35/13-05V 30 Hesketh Street  
Chevy Chase Village Historic District

**HISTORIC PRESERVATION COMMISSION STAFF REPORT**

<b>Address:</b>	30 Hesketh Street, Chevy Chase	<b>Meeting Date:</b>	10/12/2005
<b>Applicant:</b>	Beverly & Robert Haller (David Vogt, Agent)	<b>Report Date:</b>	10/5/2005
<b>Resource:</b>	Contributing Resource Chevy Chase Village Historic District	<b>Public Notice:</b>	9/28/2005
<b>Review:</b>	HAWP	<b>Tax Credit:</b>	None
<b>Case Number:</b>	35/13-05V	<b>Staff:</b>	Michele Oaks
<b>PROPOSAL:</b>	Side Addition	<b>RECOMMENDATION:</b>	Approval with condition

SUBJECT: Historic Area Work Permit # **398329 and 398330** for addition and entry stoop alterations

FLOOR PLAN FOR  
STOOP ELEVATION I

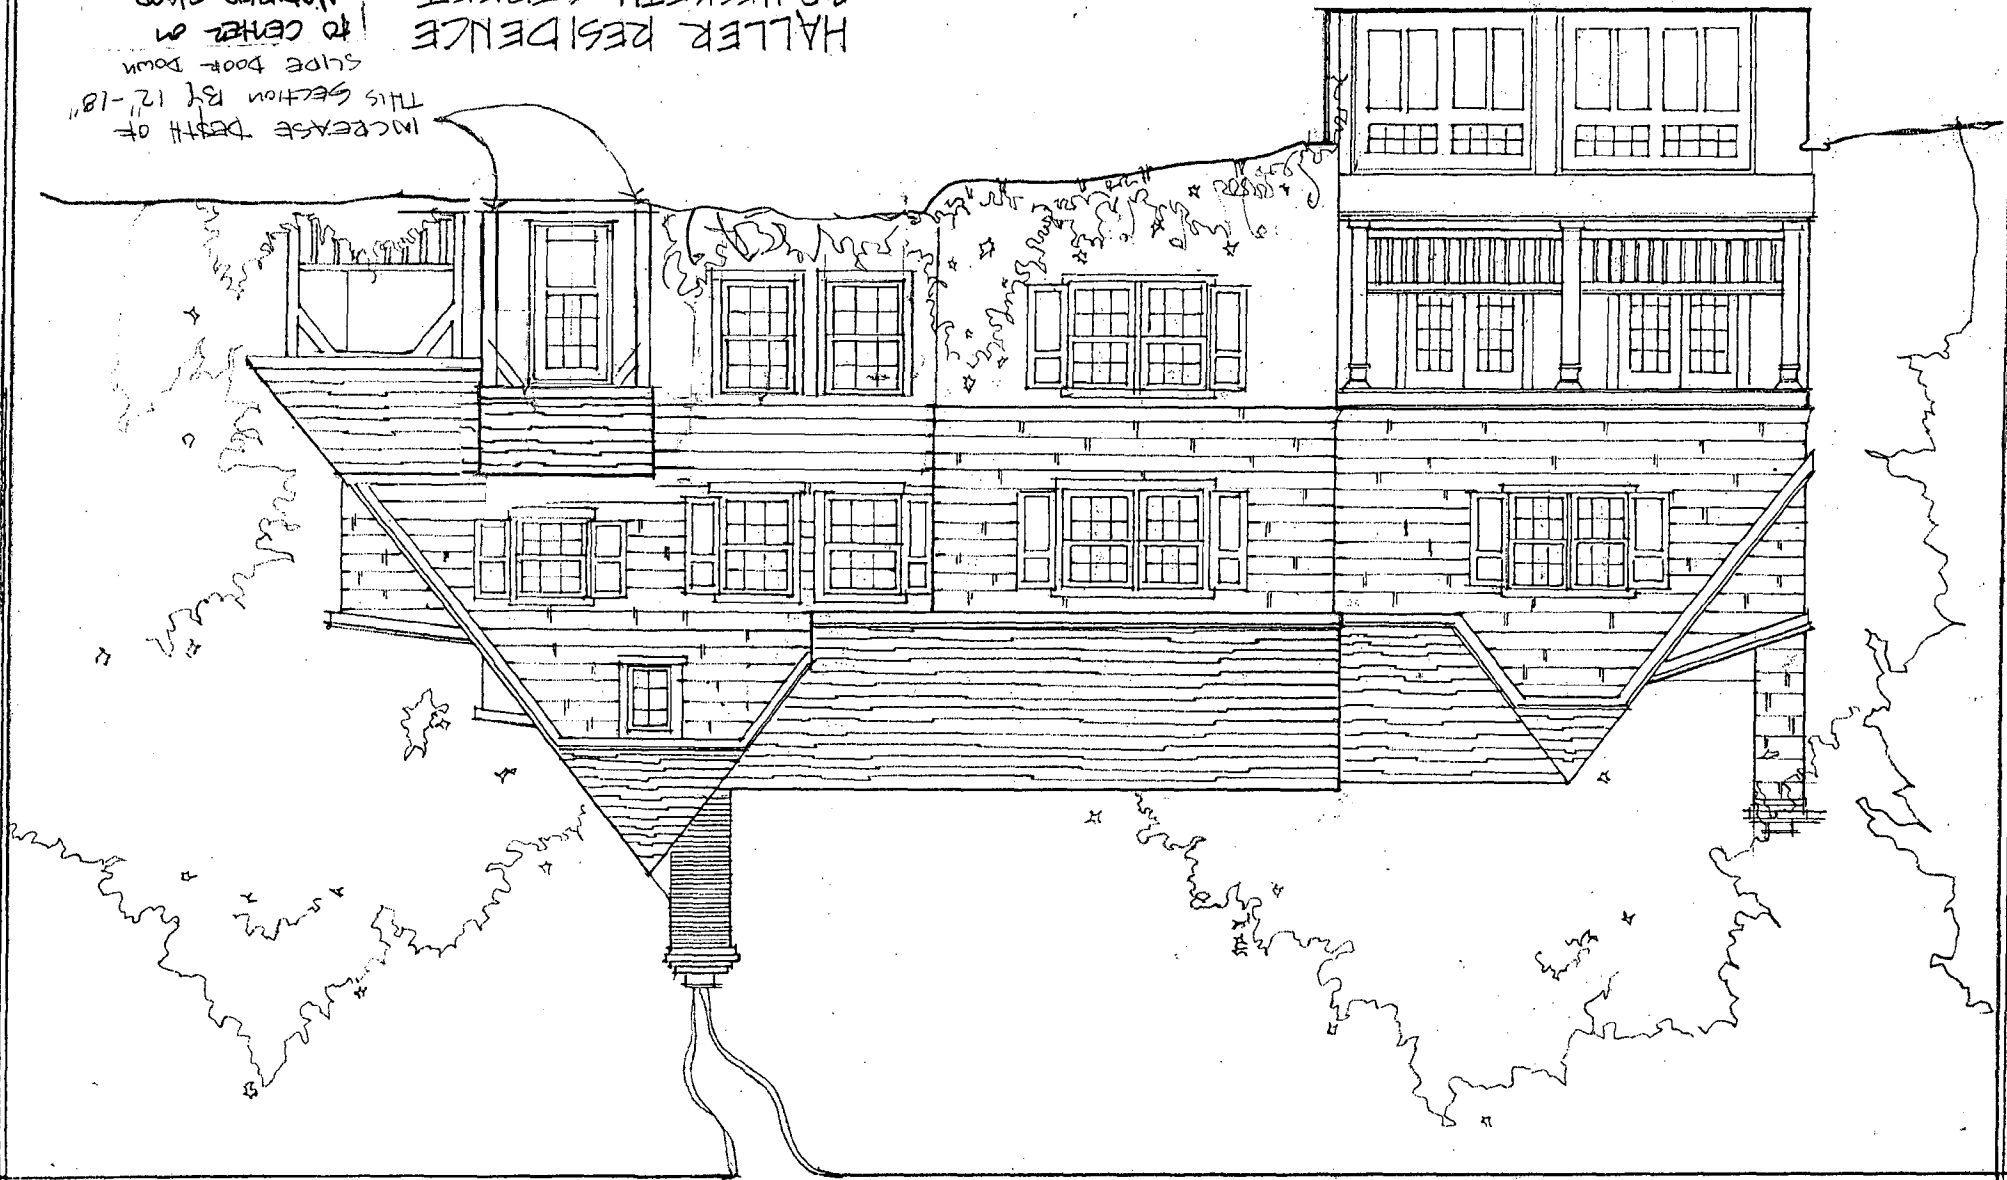
INCREASE DEPTH OF  
THIS SECTION BY 12'-18"  
SLIDE DOOR DOWN  
TO CENTER ON NEW  
GABLE.

STOOP ELEVATION 2 \* OWNER PREFERENCES

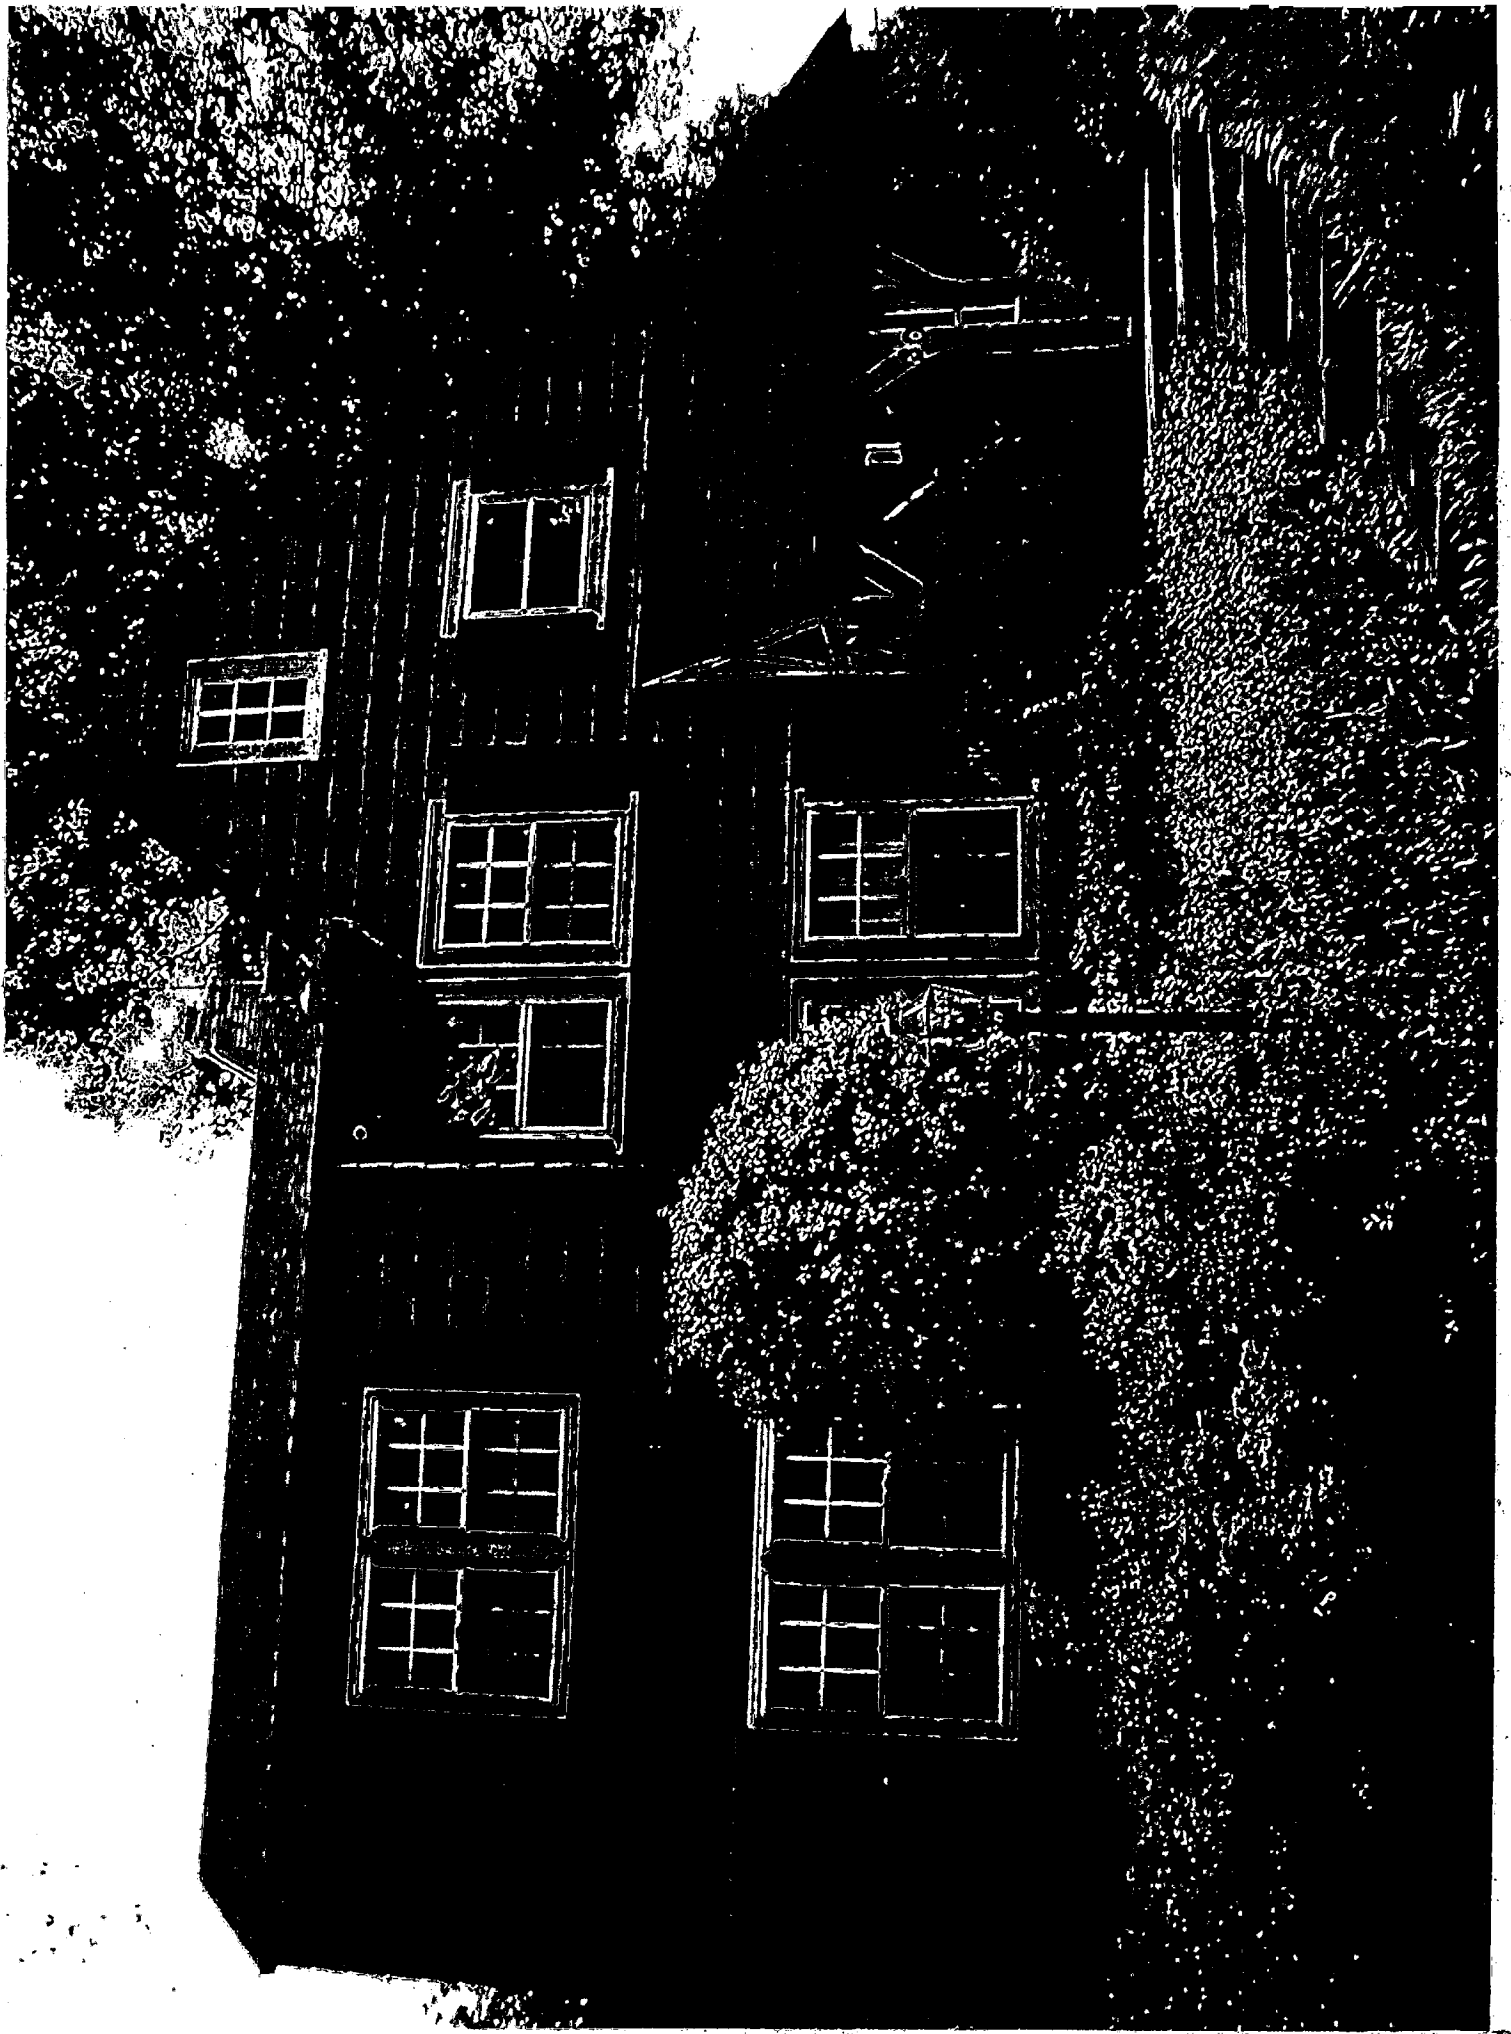
2. Relocate the post and add a clipped-cross gable to the existing porch to increase the height. Increase the depth of the left side of the porch by 12-18". The applicant would also desire to slide the front door down so that it would be centered within the new gable.
